Midway City Council
4 December 2018
Regular Meeting

LaBarge Subdivision /
Preliminary Approval

CITY COUNCIL MEETING STAFF REPORT

Subject: **LaBarge Subdivision –Preliminary Review**

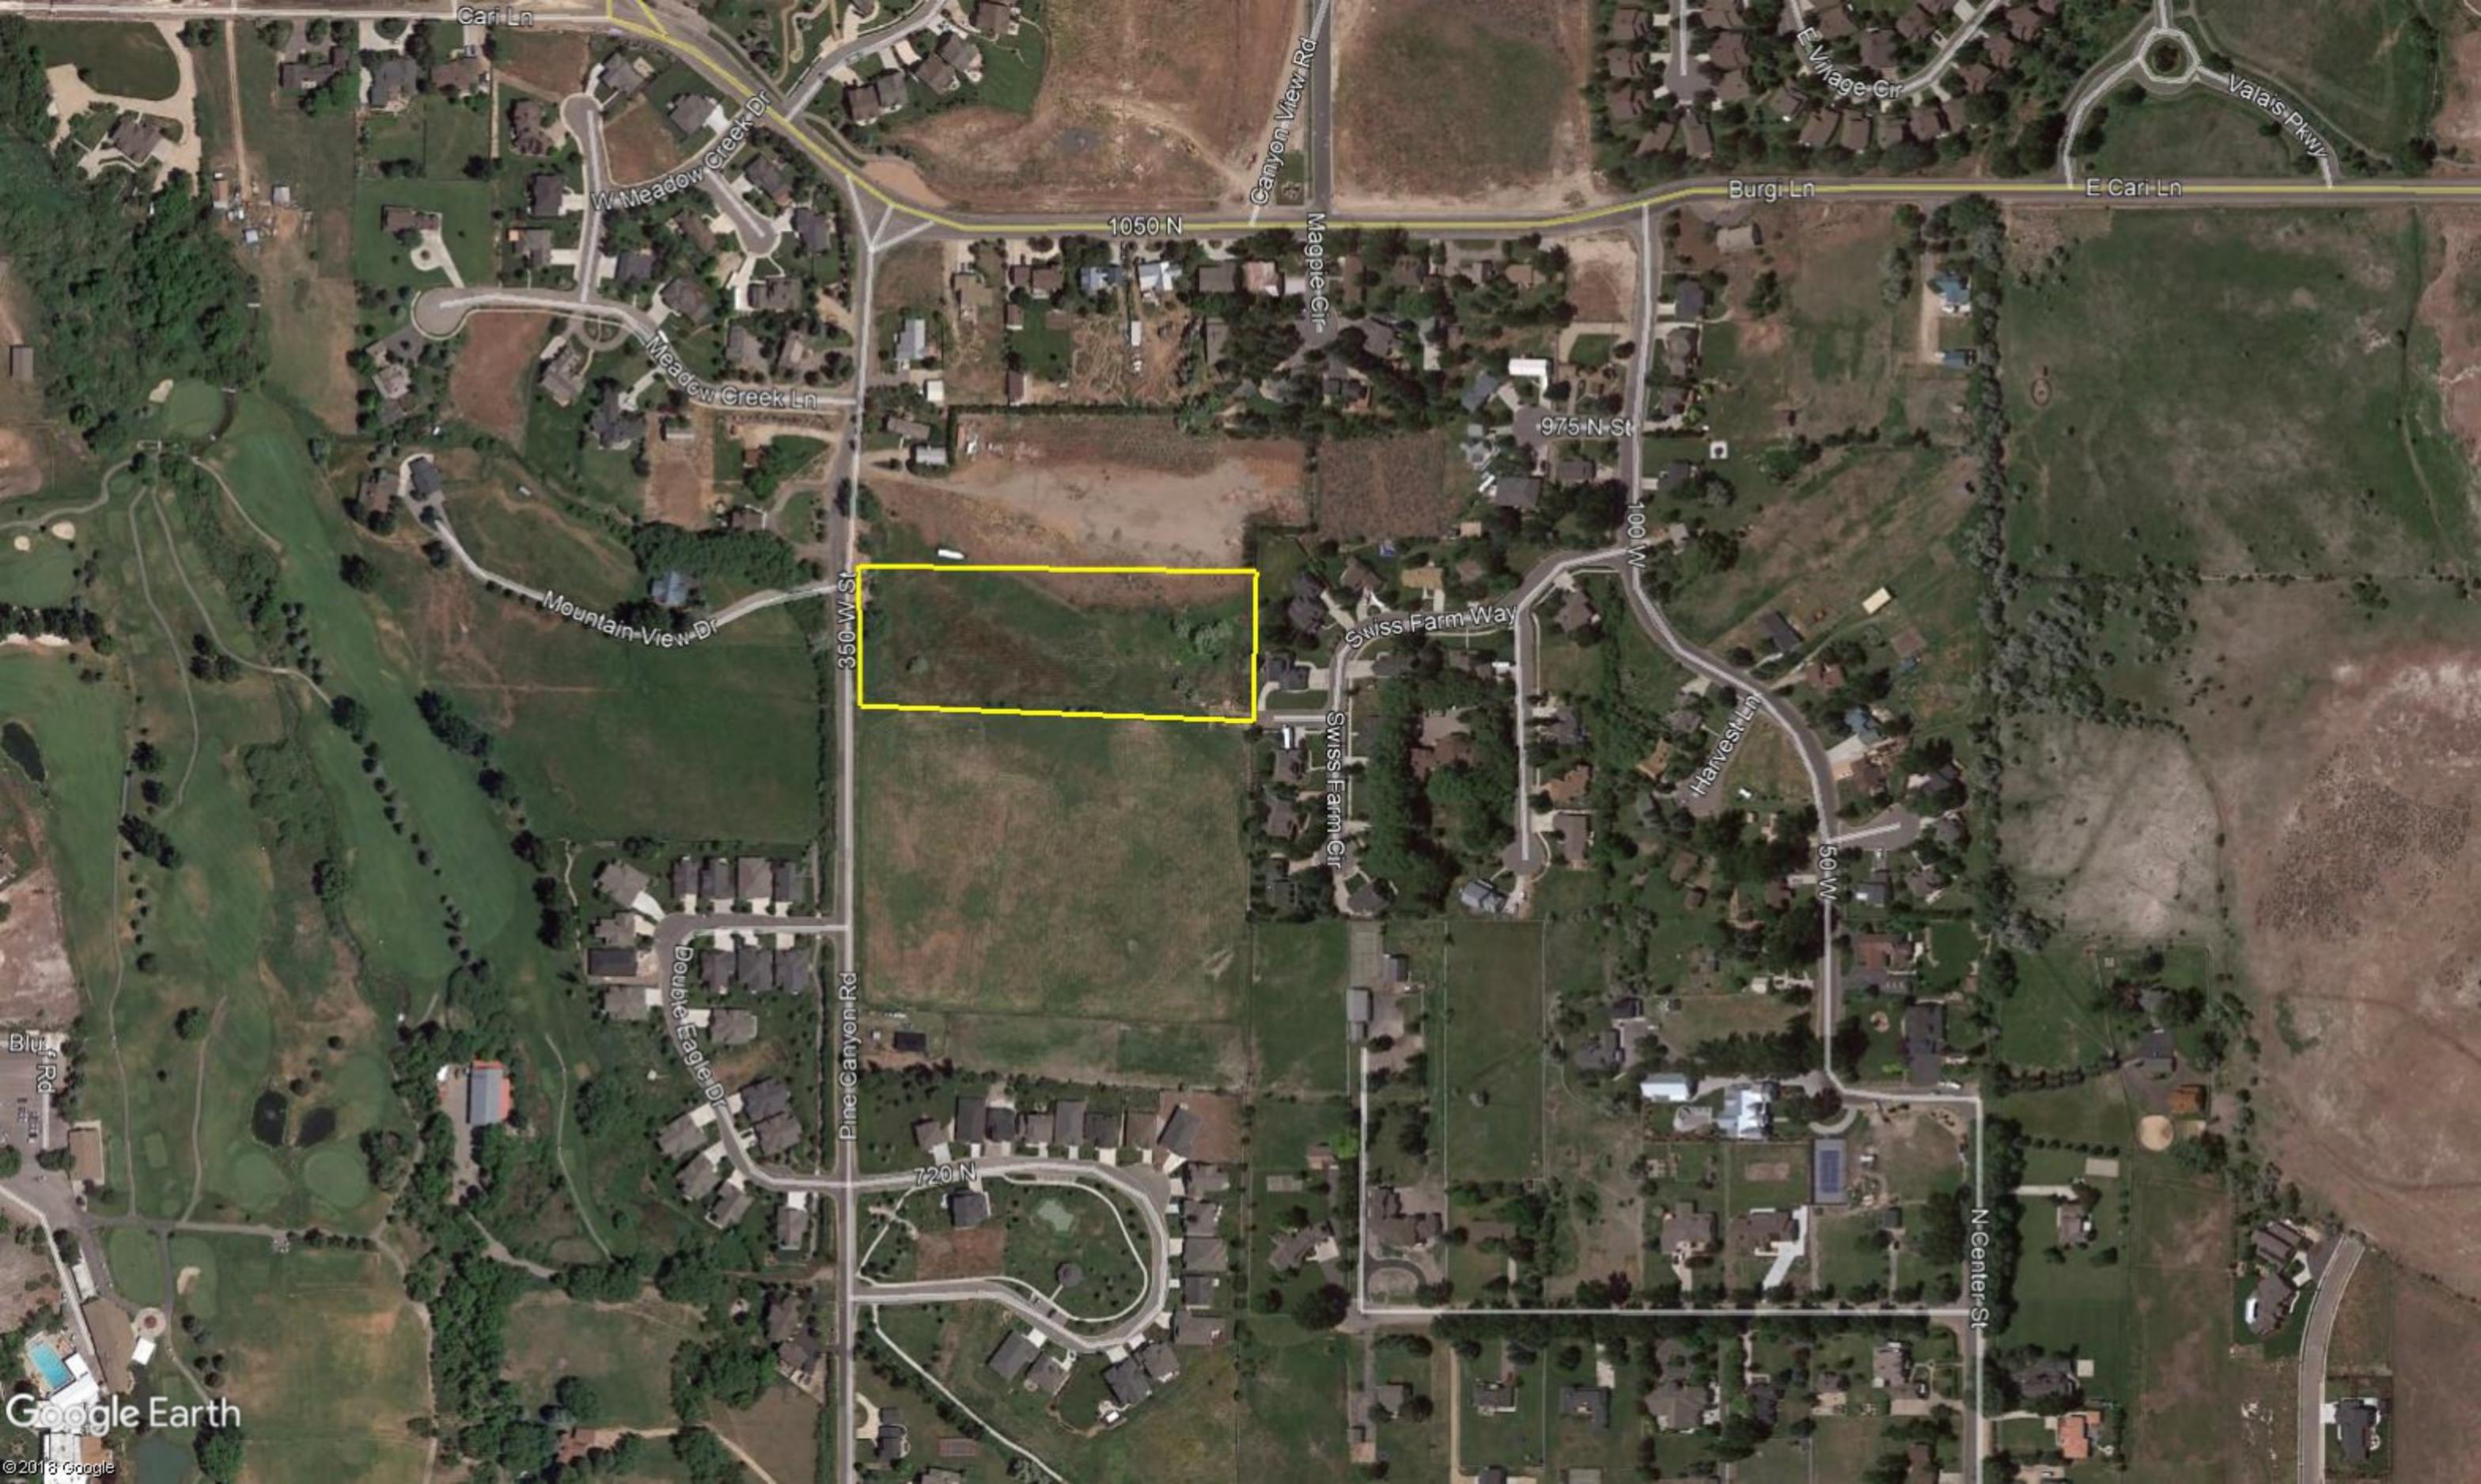
- An 8-inch water line will provide water to the subdivision. This water line will connect to the existing 8-inch water line within the Swiss Farm Subdivision.

- The subdivision is proposing to install a cul-de-sac connecting to the Swiss Farm Way stub road. To allow for future connectivity a road should be stubbed to the South.
- This subdivision is proposing to use the flat concrete ribbon curb matching the existing ribbon curb within the Swiss Farm Subdivision. Approval for the use of this cross-section must be **approved by the Planning Commission and the City Council.**
- A 5' sidewalk should be installed around the cul-de-sac and on each side of the proposed road, with a 5' park strip. Lot 1 should be responsible to provide maintenance to the south park strip until the property to the South is developed.
- The road within this subdivision will be a public road.

- No trails are planned for the proposed subdivision.

- Final plans will show the design of the storm drain system.
